Request for Class II Permissive Change(C2PC)

FCC ID: VG8XM025FXX-Y

Data: 2016-6-8

1. Changed Mother -board as below.

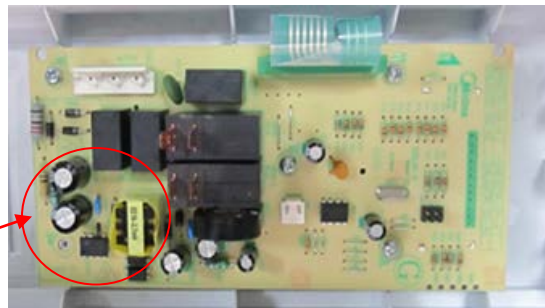
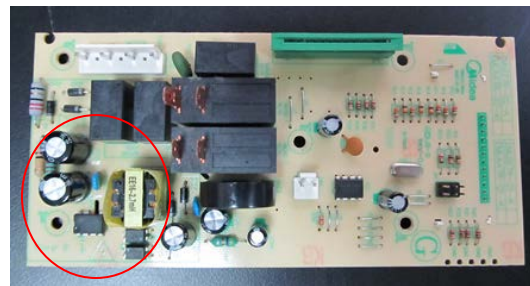
Original Mother board-top view

New Mother board –top view
AM025FTR

- 1.1 Line transformer change to Switching power supply.
- 1.2 They have the same input&output power and similar circuit function.

Only differences for component and PCB Layout as below:

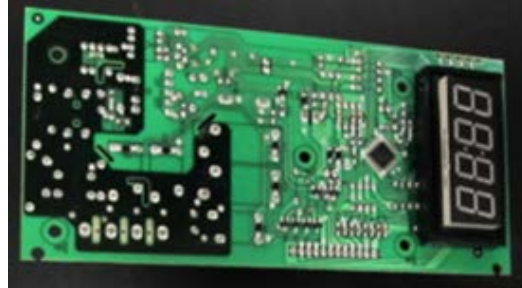
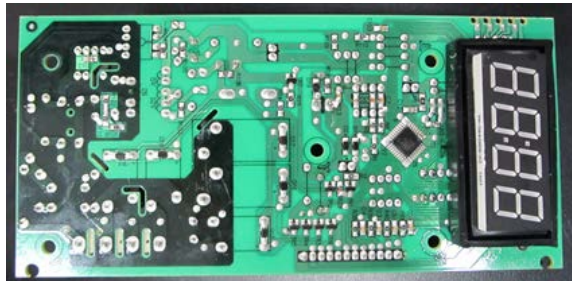
Original Mother board -bottom

New Mother board –bottom

2. Exterior view as below:

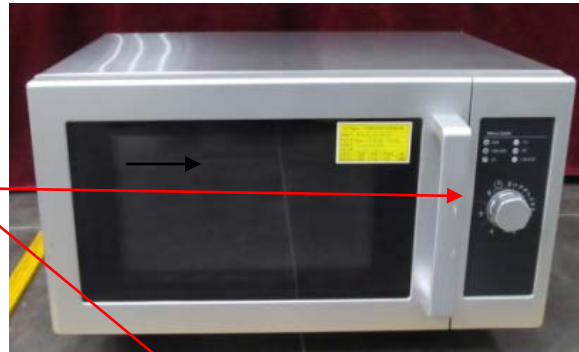
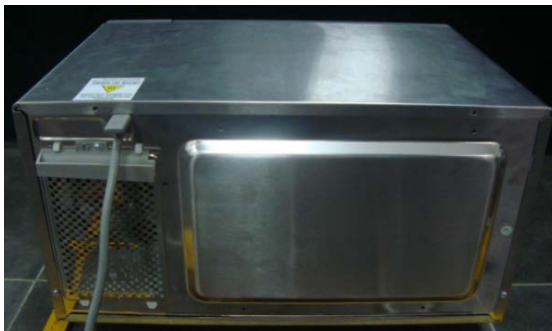
AM025FTR

EM025FTR
